SEQUOYAH NUCLEAR PLANT (SQN) - UNITS 1 AND 2 - GENERIC LETTER 2004-02 - POTENTIAL IMPACT OF DEBRIS BLOCKAGE ON EMERGENCY RECIRCULATION DURING DESIGN-BASIS ACCIDENTS AT PRESSURIZED WATER REACTORS - RESPONSE TO REQUEST FOR ADDITIONAL INFORMATION (TAC NOS. MC4717 AND MC4718)

SEQUOYAH NUCLEAR PLANT (SQN) UNITS 1 AND 2 GENERIC LETTER 2004-02 RESPONSE TO REQUEST FOR ADDITIONAL INFORMATION

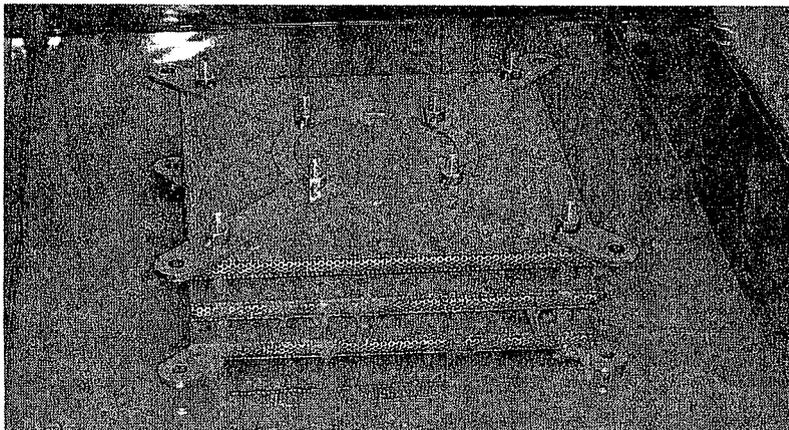
Provide the basis for the statement that a thin bed (1/8) inch of fiber cannot form on the strainer considering the design basis loading (200 pound latent debris) and design basis strainer size (1000 square feet).

This is supported by the SQN strainer head loss testing, which demonstrated that for a beyond design basis debris load much of the strainer area was free of fiber debris. The photograph below was taken after completion of Test 5 described in Item 3.f.4 of the SQN GL 2004-02 supplemental response.

In Test 5, the amount of latent fiber (fine NUKON) tested was 10 times the design basis debris load. Even with the additional fiber amount, a uniform thin bed was not formed. RMI was not included in this test as it was found not to transport from previous tests. Deletion of the RMI was considered conservative since the only potential effect of the RMI would be to impede the transport of the fibrous/particulate debris.
